Amendments to the Drawings:

Appl. No. 10/679,391
Amdt. dated March 28, 2007
Reply to Office Action of November 28, 2006

Attachment: Replacement Sheets
Annotated Sheets Showing Changes

FIG.1
(CONVENTIONAL ART)

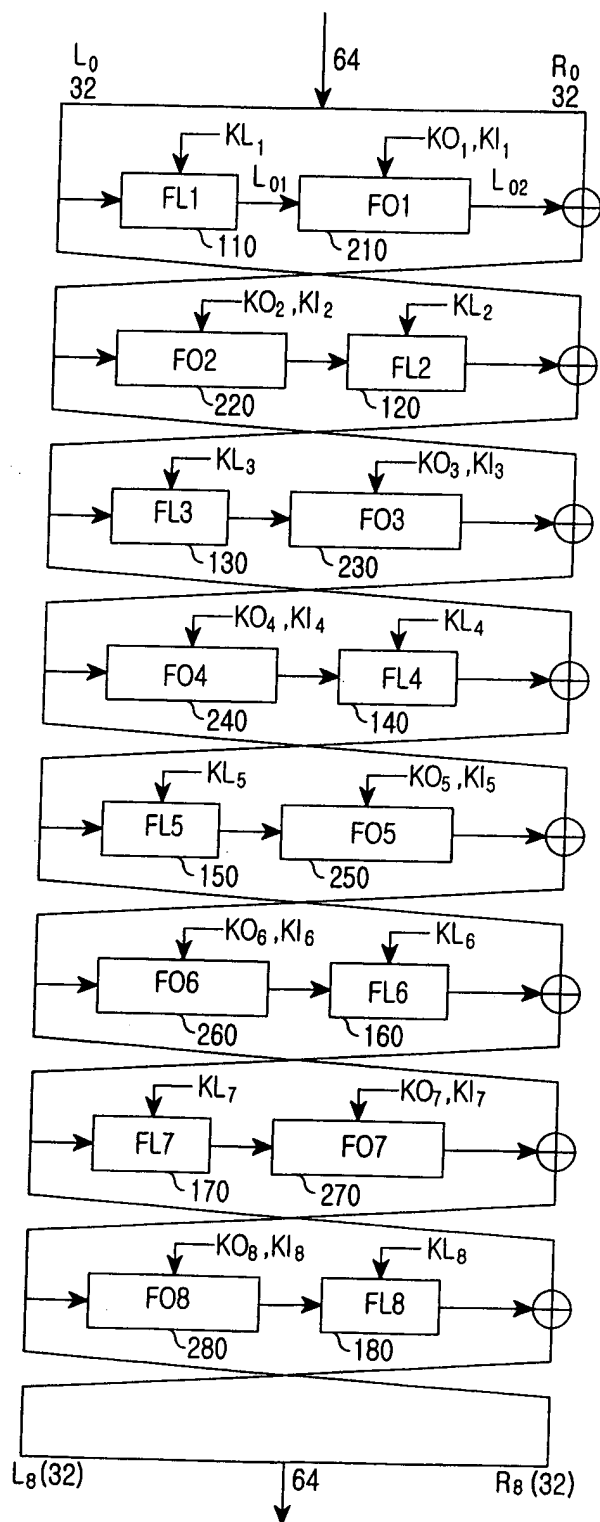
The Examiner objected to Figures 1, 2A, 2B and 3 because the figures should be designated by a legend such as --PRIOR ART--. To overcome the above objection, Applicant has added the legend -- (CONVENTIONAL ART) -- to Figures 1, 2A, 2B and 3.

FIG.3
(CONVENTIONAL ART)

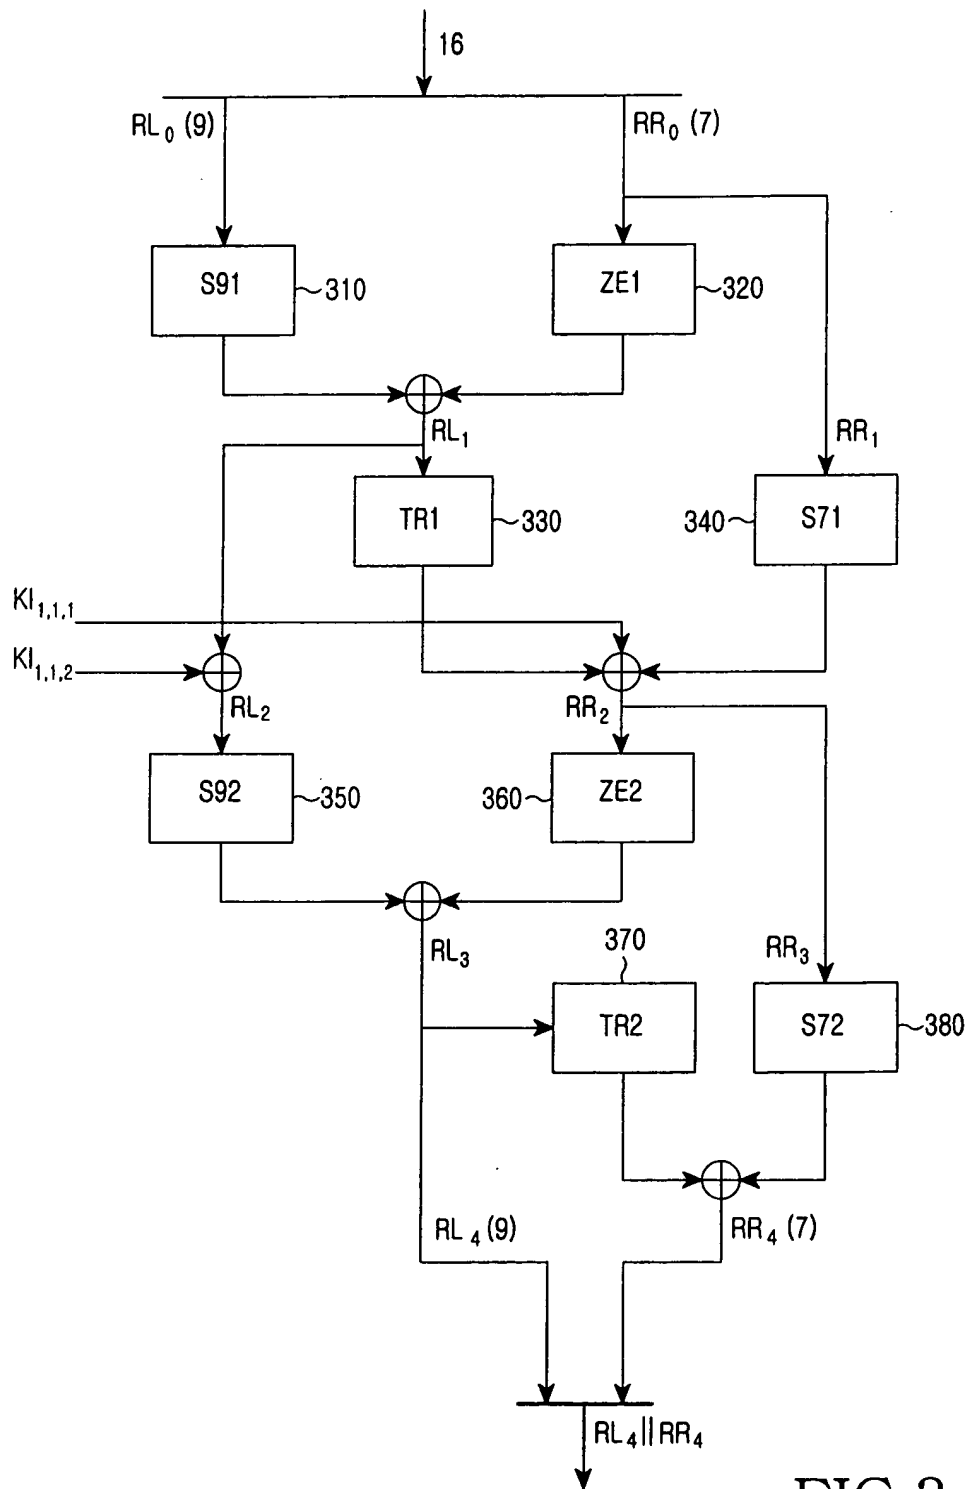
The Examiner also objected to Figure 3 and 5 because of the following informalities:

(c) Reference character "360" is used in FIG. 3 to

designate "ZE2 unit" but "Fl_{2,3}" in FIG. 5. The amendments to FIG. 5 above in (a) will overcome the Examiners objection to FIGs. 3 and 5.

(d) Reference character "360" is used to receive the signal

"RR₁" in the specification (page 6, line 5) but "360" is used to receive the signal "RR₂" in FIG. 3. To overcome the Examiner's objection to FIG. 3, Applicant has amended the specification on page 6, lines 5 and 6 to change "RR₁" to --RR₂--.

FIG.5

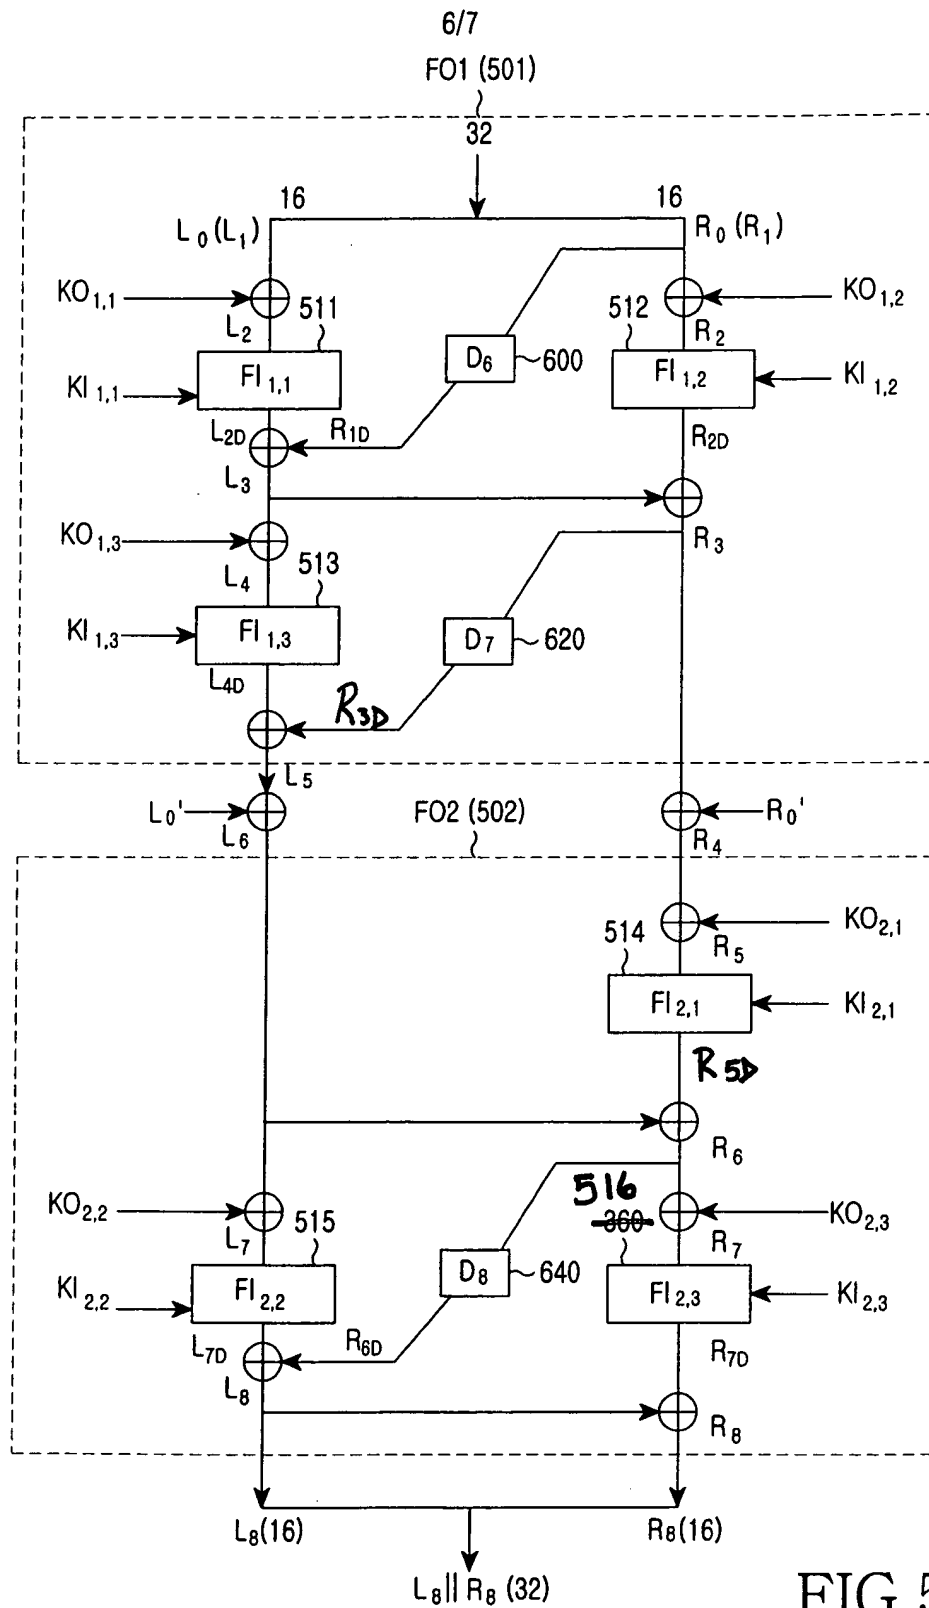
(a) Reference character "516" is used in specification

(page 12, line 26) but "360" is used in FIG. 5 to designated "Fl_{2,3}". To overcome the Examiner's objection to FIG. 5, Applicant has changed reference numeral "360" to --516--.

(b) Reference character "515" is used to designate "FL_{2,2}"

in specification (page 12, line 21) but "Fl_{2,2}" in FIG. 5. To overcome the Examiner's objection to FIG. 5, Applicant has amended the specification on page 12, line 21 to change "FL_{2,2}" to --Fl_{2,2}--.

Applicant also adds reference --R_{3D}-- to the output of delay (D₇) 620 and --R_{5D}-- to the output of sub-cipher 514, although the Examiner did not make an objection.
